Model: Bellini		Date: 30-May-00	No.: RA294014
Subject: Finisher ROM History		Prepared by: H.K.	
From: Technical Services Dept., GTS Division			
Classification:	☐ Troubleshooting ☒ Part information ☐ Action required ☐ Mechanical ☐ Electrical ☐ Service manual revision ☐ Paper path ☐ Transmit/receive ☐ Retrofit information ☐ Other ()

Model: Bellini		Date: 26-Jun-00	No.: RA294021
Subject: Finisher - Punch Waste Full Condition		Prepared by: H.K.	
From: Technical Services Dept., GTS Division			
Classification:	☐ Troubleshooting ☐ Mechanical ☐ Paper path ☐ Other ()	☐ Part information ☐ Electrical ☐ Transmit/receive	☐ Action required ☒ Service manual revision ☐ Retrofit information

Model: Bellini		Date: 06-Jul-00	No.: RA294022
Subject: Finisher: Poor Front Cover Sheet Positioning		Prepared by: H.K.	
From: Technical Services Dept., GTS Division			
Classification:	☒ Troubleshooting ☐ Part information ☐ Action required ☐ Mechanical ☐ Electrical ☐ Service manual revision ☐ Paper path ☐ Transmit/receive ☐ Retrofit information ☐ Other ()

Model: Bellini		Date: 06-Oct-00	No.: RA294033
Subject: SC729(Punch Motor Failure)		Prepared by: S. Hizen	
From: Technical Services Dept., GTS Division			
Cla

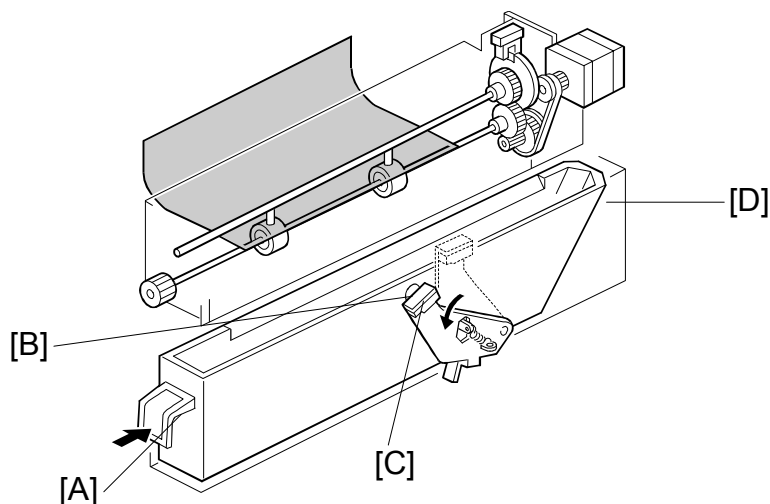
This is the solution for the following problem that was reported:

When the paper stack is removed when the tray is full, the stack height sensor feeler drops. Then, 1.5 seconds later, the finisher raises the tray and sends the "wait" signal to the copier. The copier then immediately stops the paper flow exiting to the finisher. When the tray is lifted to the top position, the finisher sends the "wait clear" signal to the copier. Then, the copier restarts exiting the paper to the finisher.

If the copier does not receive the "wait" signal, it restarts exiting the paper immediately.

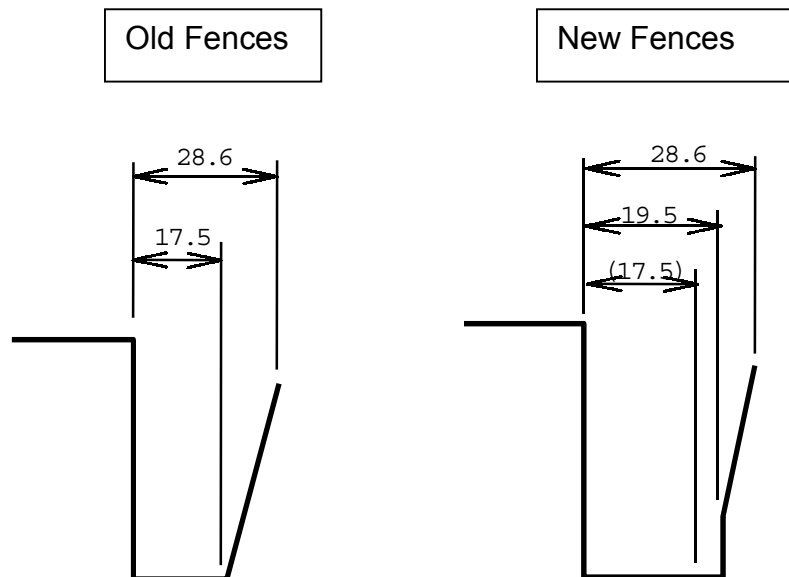
The widths of the positioning fences (front, middle and rear) have been increased as shown below.

Note 1: When replacing either of the old fences in the field, install all three new parts as a set.

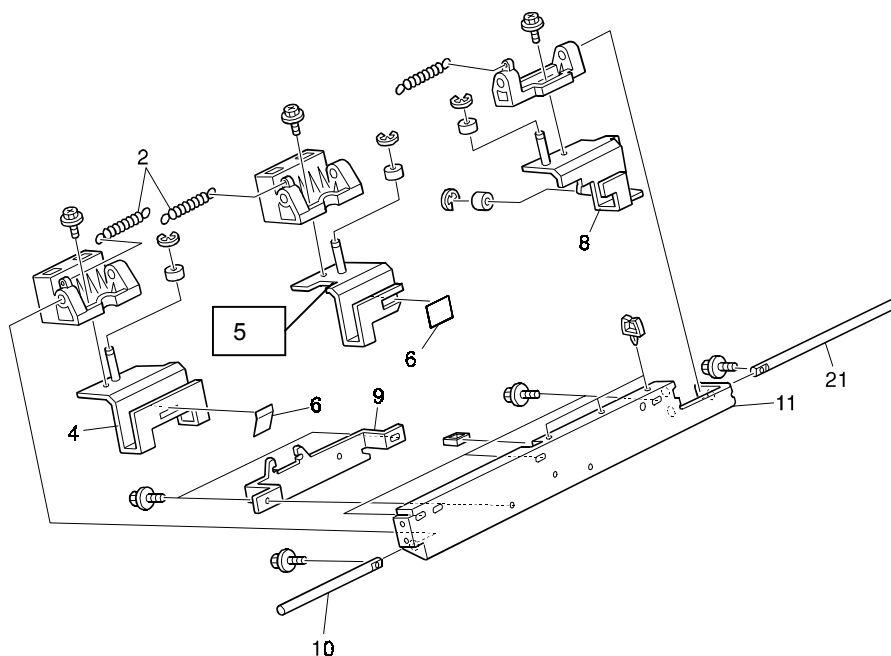
Note: In addition to installing the new three fences, it is necessary to attach two Mylar Guides (B3024517, Index 6) to the Front and Middle Positioning Fences.

1. Remove the two springs (index 2) hooked on the Slide Holder Shaft Bracket (B3024742: Index 9).
2. Remove the securing screws for the front and rear shafts (B3024541: Front Shaft - Slide Holder, Index 10 & B3014542: Rear Shaft - Slide Holder, Index 21).
3. Slide out the front and rear shafts from the Staple Unit Lower Stay (B3024741: Index 11).
4. Remove the old positioning fences (Index 4, 5, and 8).
5. Attach the two Mylar Guides (B3024517: Index 6) to the Front and Middle Positioning Fences as shown in the illustration on the next page.
6. Install the new positioning fences (front, middle, and rear).
7. Return all removed parts.

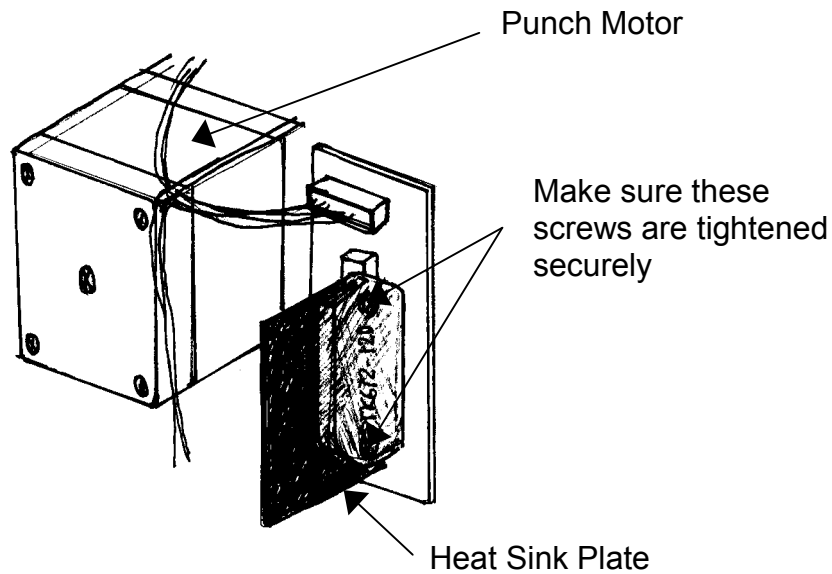
- 2 From September 2000 production of the punch units, the heat resistor securing screws have been locked in place with an adhesive.

P/N change:

Old Punch Drive Board P/N: A812-5120

New Punch Drive Board (Heat resistor screw lock) P/N: A812-5150

3-1 Please check the two heat resistor screws when visiting the machine site and tighten them if they are loose.

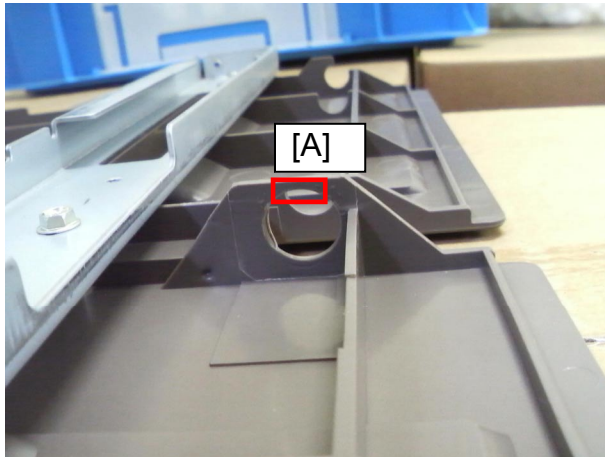
- 11. Remove the old shaft from the gear.**

- 12. Remove the E-ring.**

- 13. Remove the pin.**

- 14. Insert the new shaft into the gear, using the E-ring and pin you removed in Steps 12 and 13.**

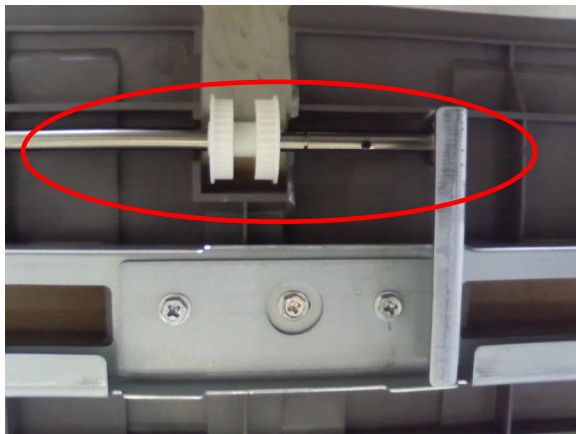
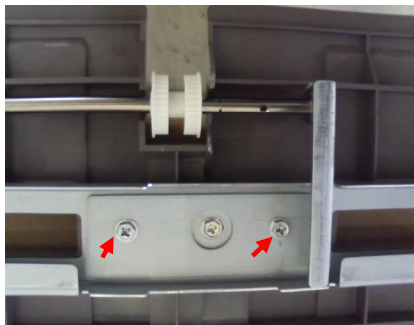
15. Cut off the rib [A].

16. Attach the new bracket (P/N B8304784).

20. FRAME SECTION 1 (B706)

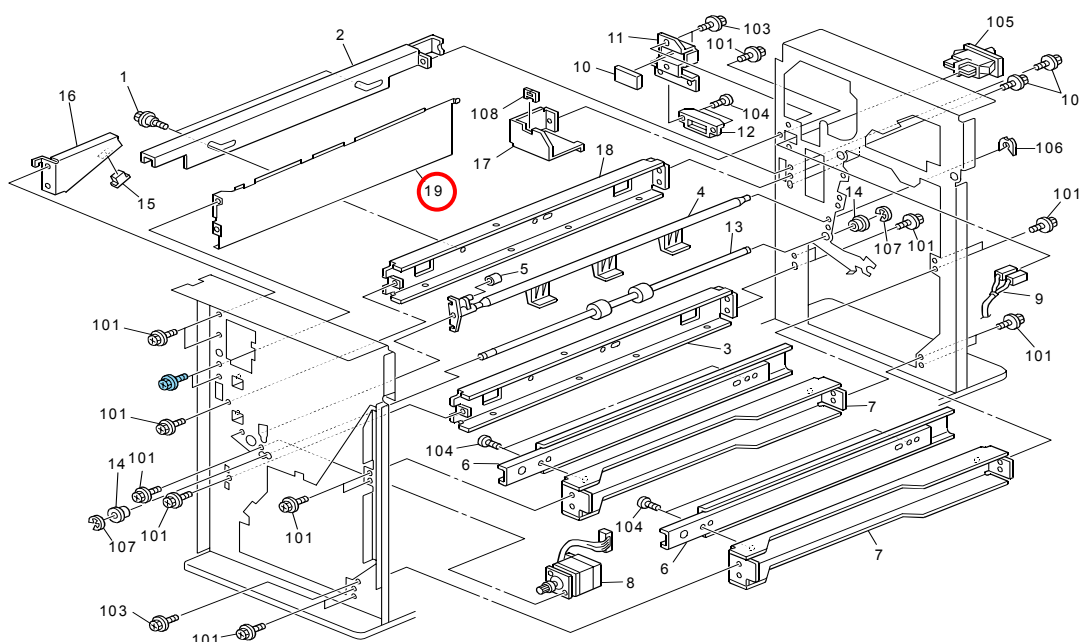
- 1) ***A cover for the door switch harness was added.***
- 2) ***In accordance with this change, a screw hole was added to the safety switch cover and a tapping screw added.***

Reason: To further protect the harness from physical contact.

Important: The newly-added door switch harness cover (D4601146) cannot be installed on machines produced before the cut-in serial numbers. On these machines, be careful not to touch the harness when you service the machines.
